TRANS/WP.29/2002/64
23 August 2002

PROPOSAL FOR DRAFT SUPPLEMENT 7 TO REGULATION No. 43

(Safety glazing)

Transmitted by the Working Party on General Safety Provisions (GRSG)

The example titled "Rigid plastic glazings other than windscreens", amend to read:

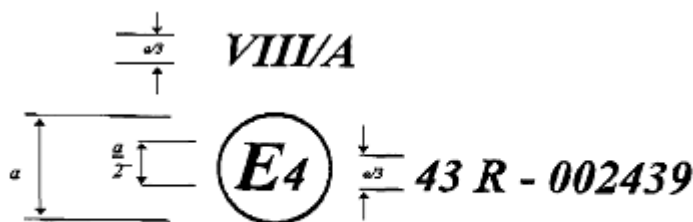
a = 8 mm min.

The above approval mark affixed to a rigid plastic glazing pane for forward facing panels with a light scatter not exceeding 2 per cent after 1000 cycles on the outer surface and 4 per cent after 100 cycles on the inner surface shows that the component concerned has been approved in the Netherlands (E 4) pursuant to Regulation No. 43 under approval No. 002439. The approval number indicates that the approval was granted in accordance with the requirements of Regulation No. 43."

Model A
(see paragraph 5.11. of this Regulation.)

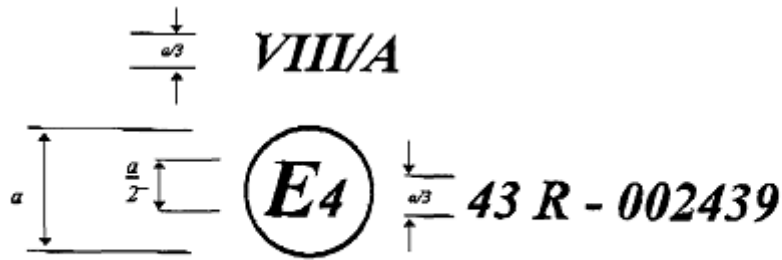
Insert a new annex 2B, to read:

a = 8 mm min.

The above approval mark affixed to a vehicle shows that the vehicle type concerned has, with regard to installation of glazing, been approved in the Netherlands (E4) pursuant to Regulation No 43. The approval number indicates that the approval was granted in accordance with the requirements of Regulation No. 43.
